L-2010-295
10 CFR 52.3

December 15, 2010

Re: Florida Power & Light Company
Proposed Turkey Point Units 6 and 7
Docket Nos. 52-040 and 52-041
NRC June 2010 Environmental Audit
Supplemental Information Request Response 2 Part 2

Figure 4.4-2 Traffic Study of Construction Entrance

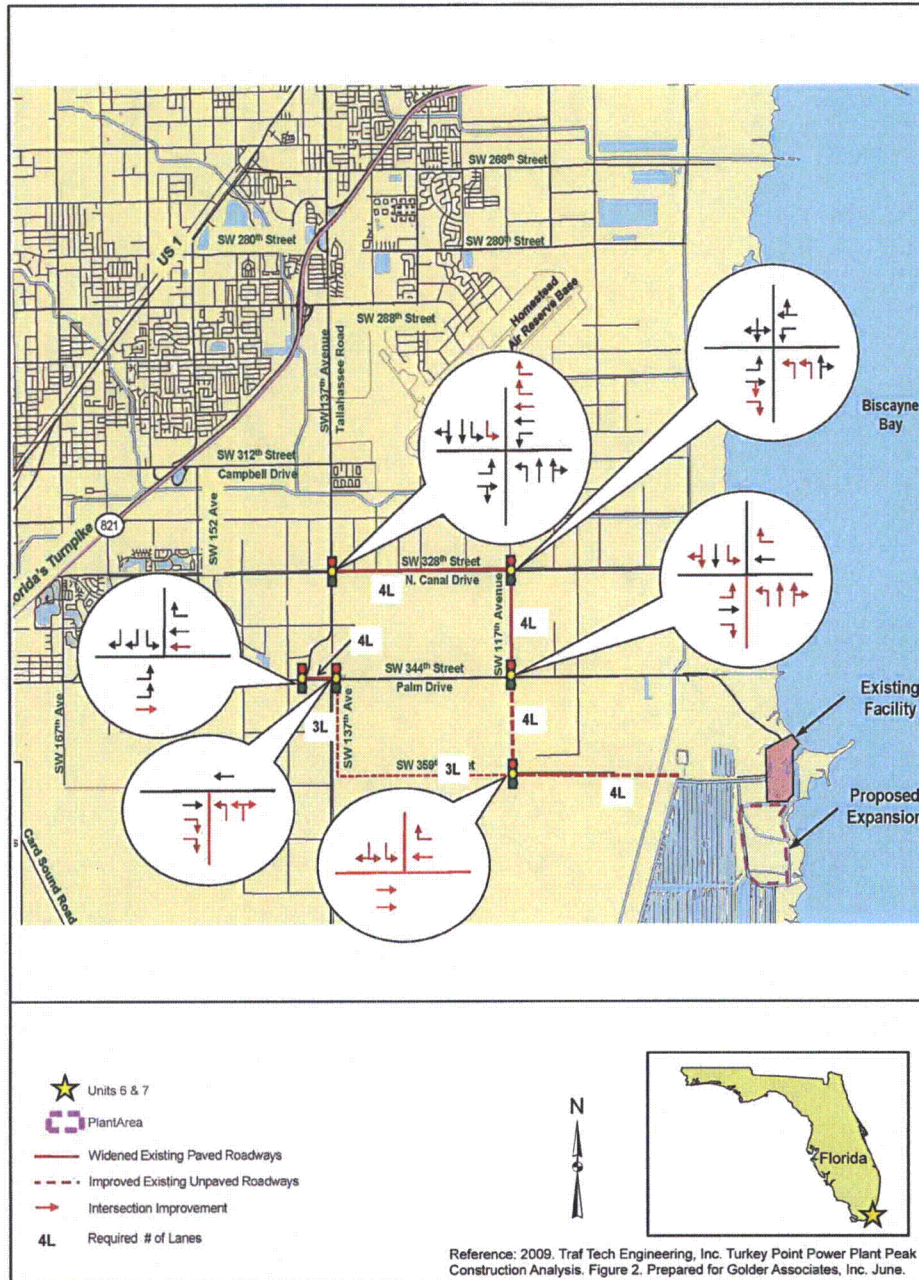
A figure of the roads (Appendix 10.7.4.1, FPL, 2009) in the vicinity of Turkey Point that will be most affected by construction traffic and their approved improvements will be added to the Environmental Report, Section 4.4, in a future revision.

Figure 4.4-2 will be added to ER 4.4 in a future revision.
